ABB-CE TRANSMITTALS OF CESSAR-DC
REVISIONS PRINTED IN AMENDMENT K

CESSAR-DC CHANGES IN AMENDMENT K
NOT PREVIOUSLY TRANSMITTED

Summary of Attachment 2

CONTAINMENT HYDROGEN CONCENTRATION vs TIME
AFTER LOCA (WITHOUT RECOMBINERS AND WITH A
SINGLE RECOMBINER START TIME OF 72 HOURS)

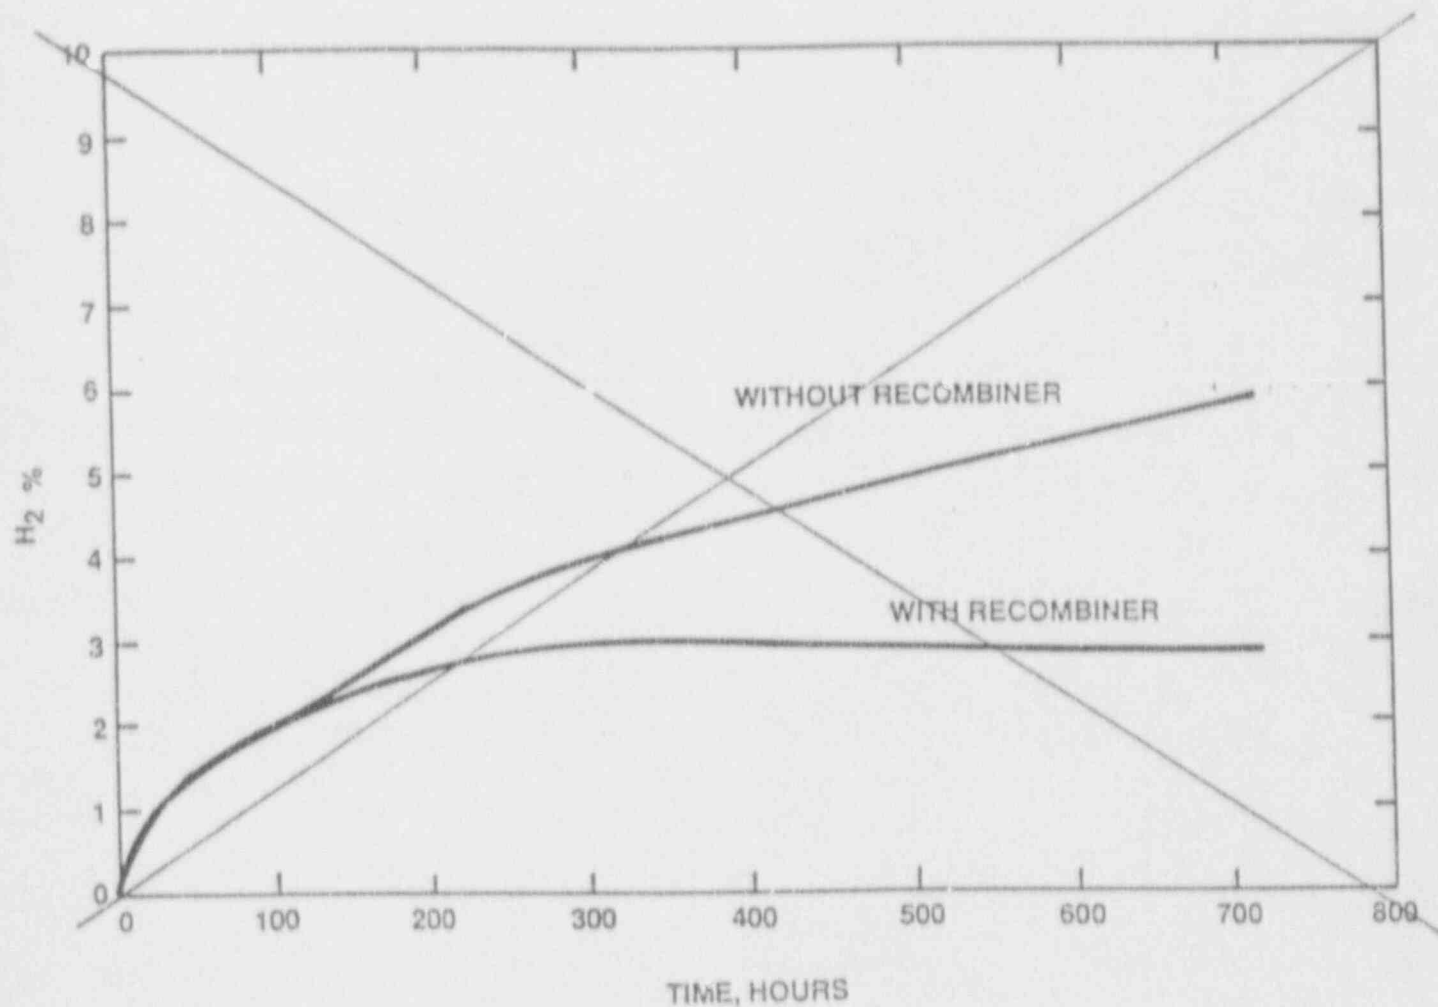
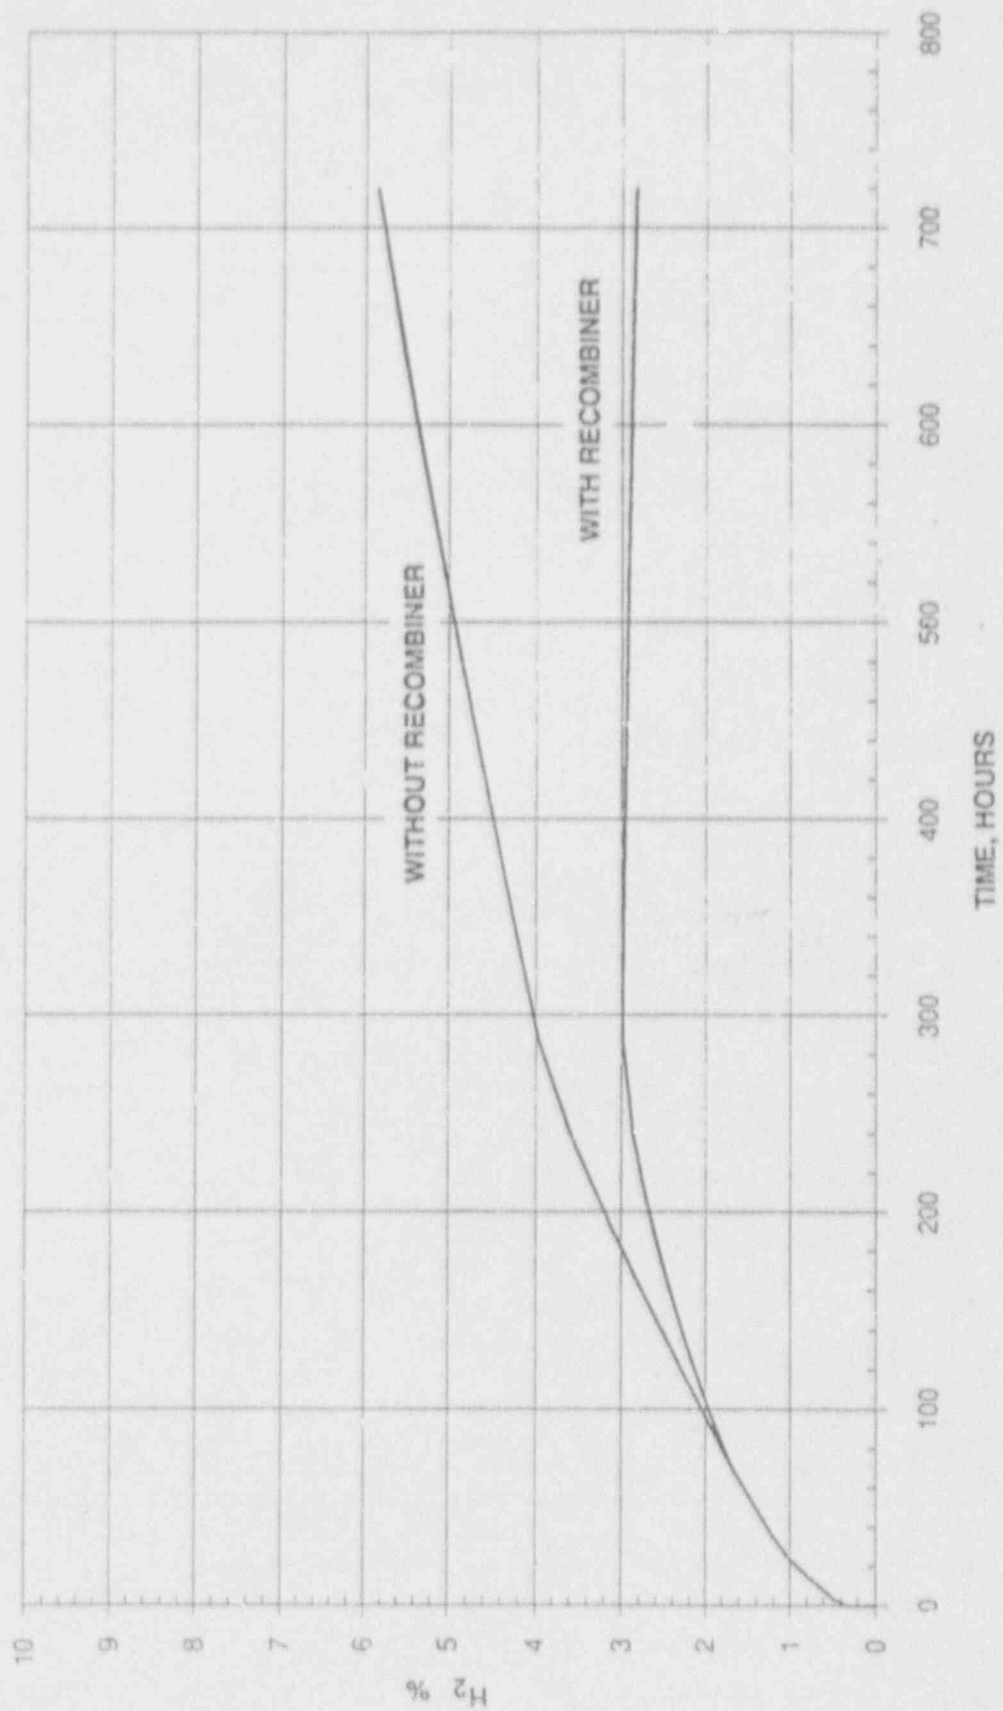
To account for single failure, only one of the 100 cfm recombiners is considered in the analysis. The flow split per recombiner is 50 cfm from containment and 50 cfm from the IRWST. Hydrogen concentration versus time is shown in Figure 6.2.5-2 for containment and Figure 6.2.5-3 for the IRWST. These figures show hydrogen concentration without recombiner flow and with a single recombiner started 72 hours after the LOCA.

Replace With
Following Page

Figure
6.2.5-C

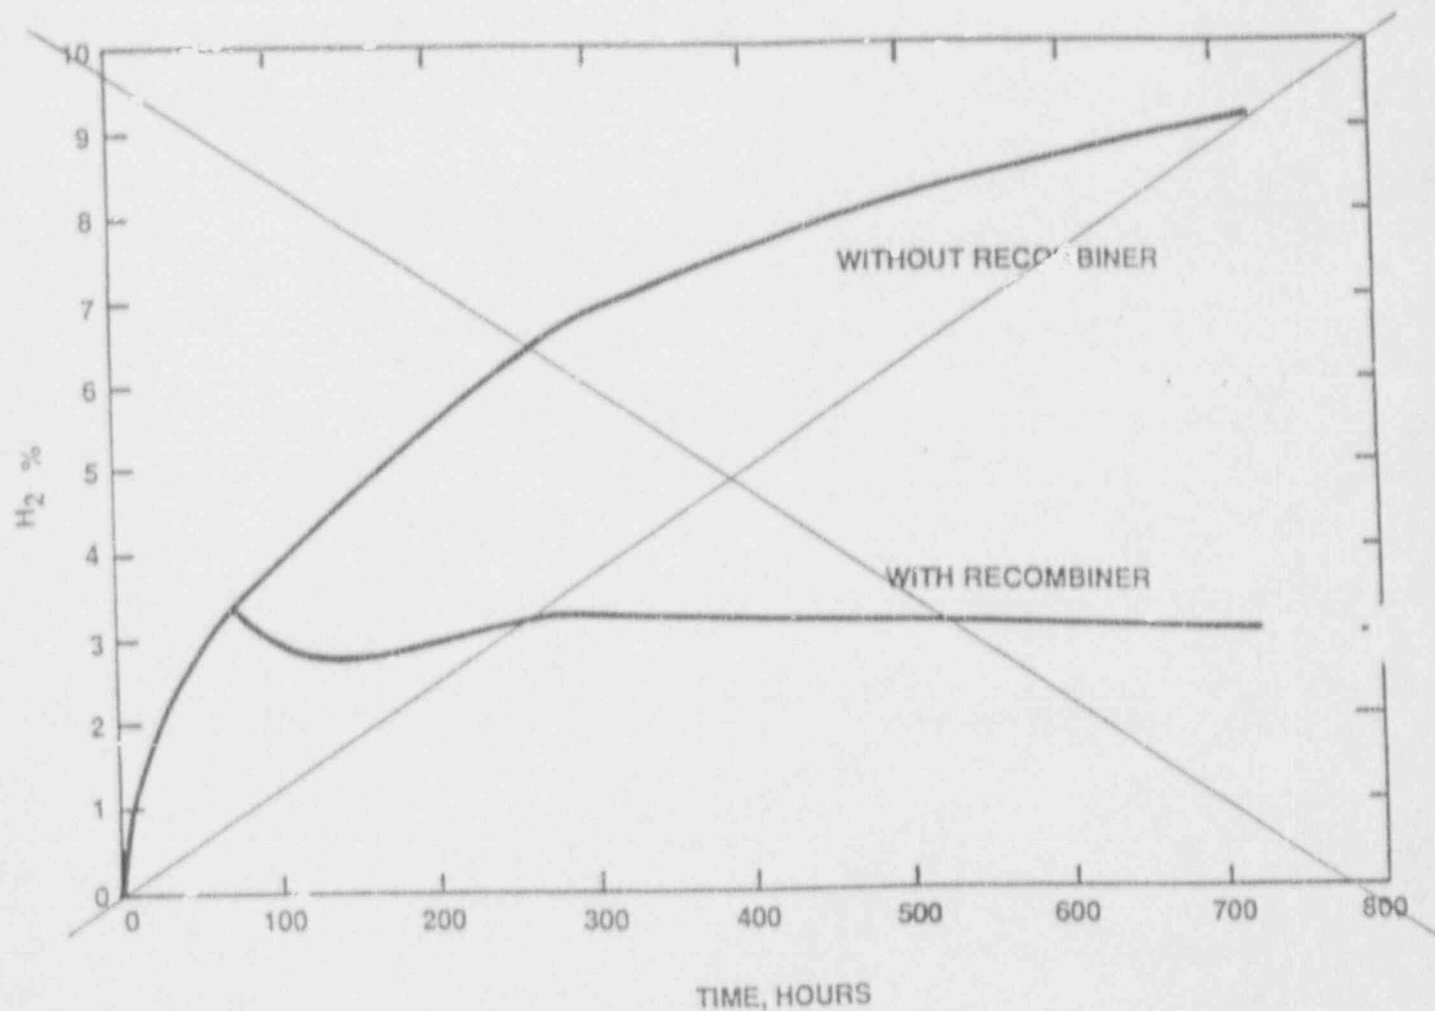
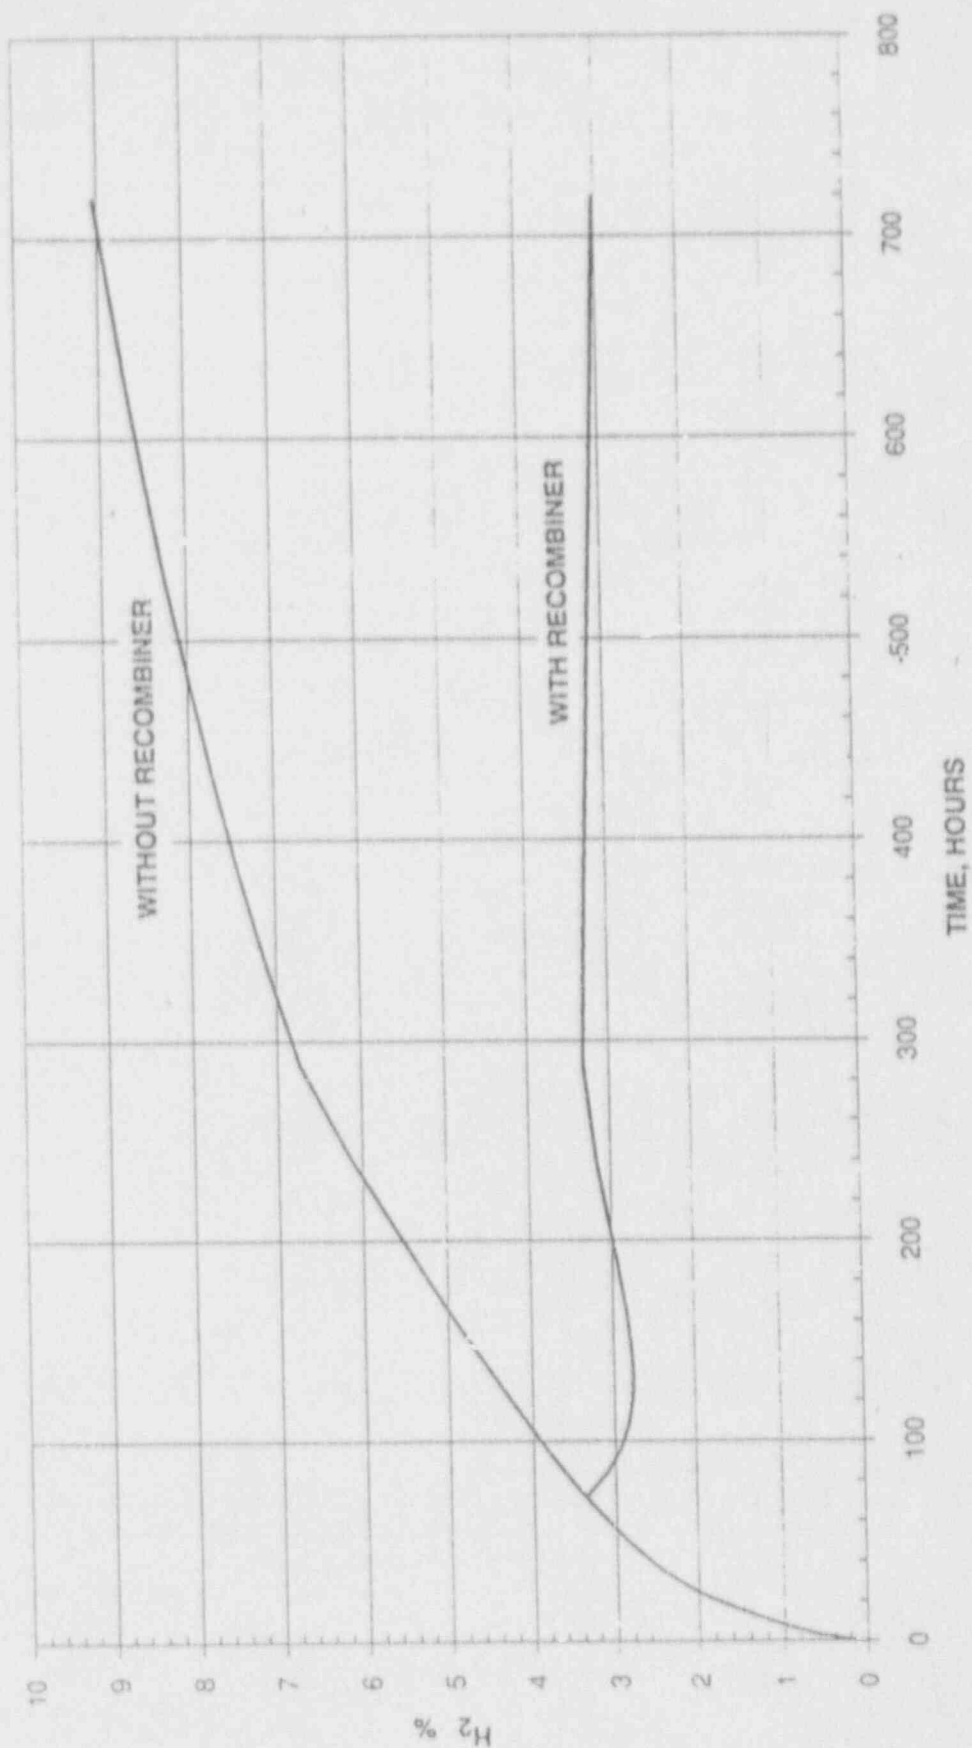
Replace With
Following Page

IRWST HYDROGEN CONCENTRATION vs TIME
AFTER LOCA (WITHOUT RECOMBINERS AND WITH A
SINGLE RECOMBINER START TIME OF 72 HOURS)
